CATHCART TERRACE SUBDIVISION W/MODIFICATION OF STANDARDS

Staff Recommendation: Approval of the Minor Plat with Modification of Standards, per the conditions in this staff report.

PROPOSED SITE PLAN

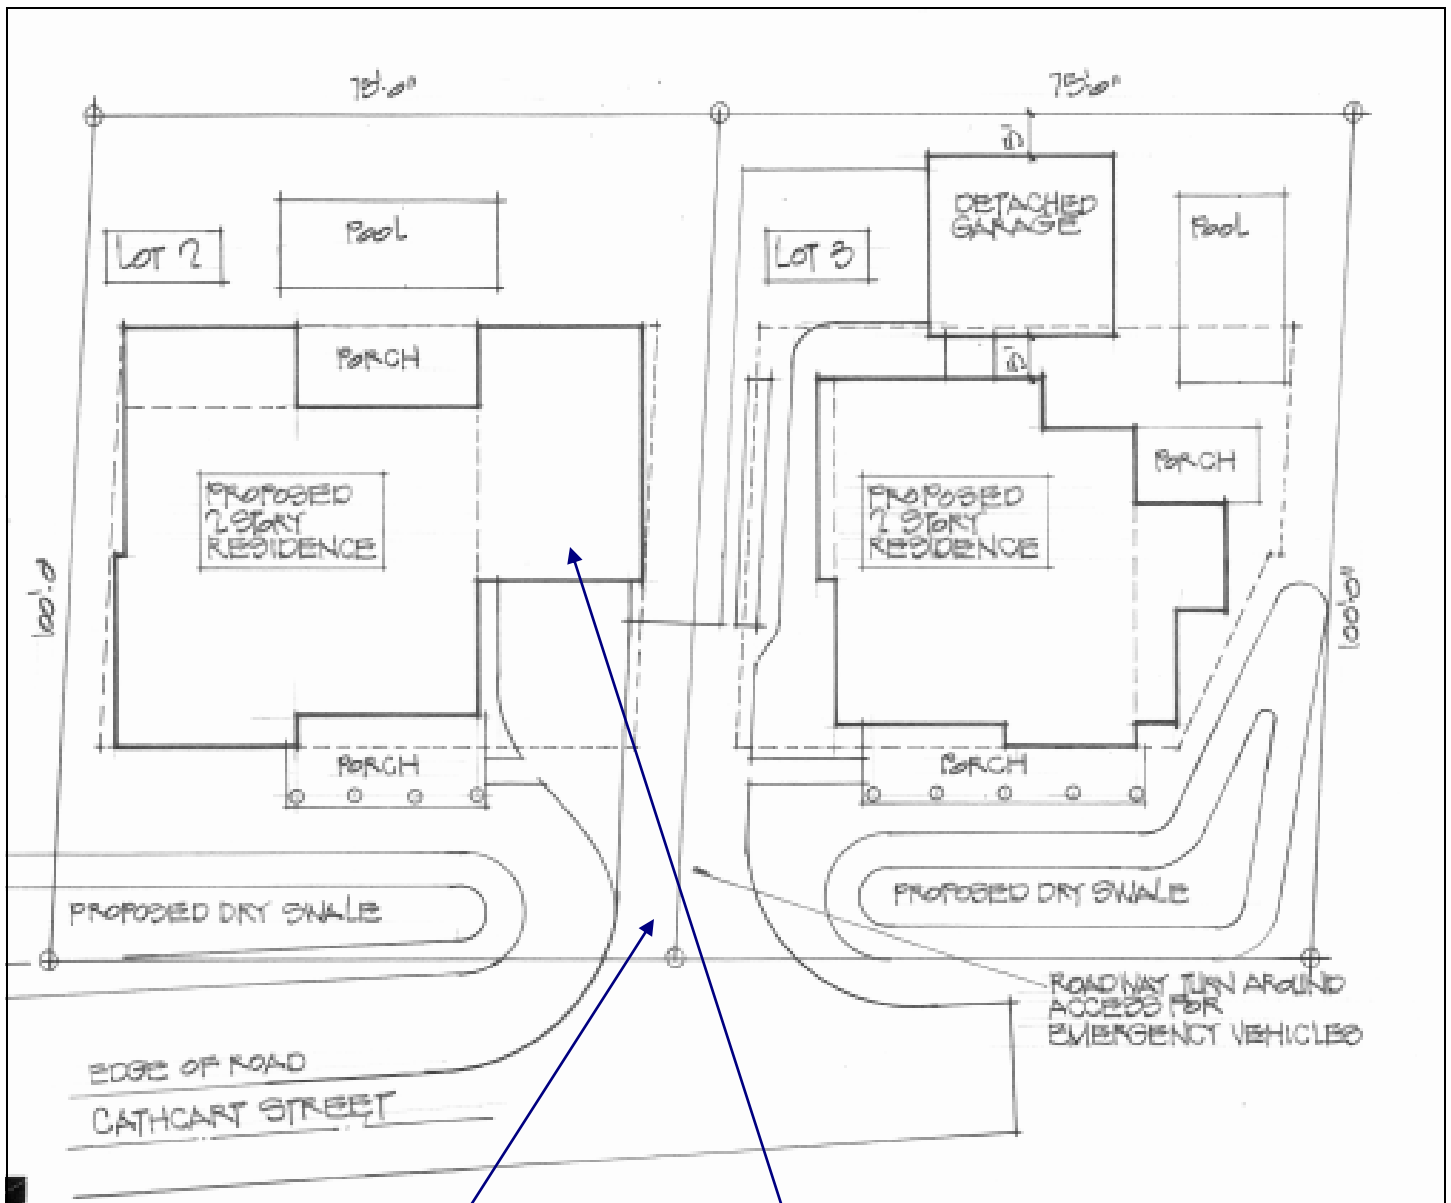
To show the proposed easement, this site plan is shown in full. The applicant has agreed to replace the attached garage on Lot 2 with a detached garage in the rear to provide ample parking space behind the required easement where no parking will be permitted. He will be allowed to create a front loaded detached garage in the rear if all other code requirements are met including ISR and setbacks. The applicant is also allowed to create Lot 3 in mirror image for Lot 2. Lastly, the applicant has agreed to erect a no parking sign in the easement.

Required 43 ft. by 24 ft. easement for emergency vehicles.

City staff condition: Must become a detached garage in the rear. May be front or side loaded. See page 11.
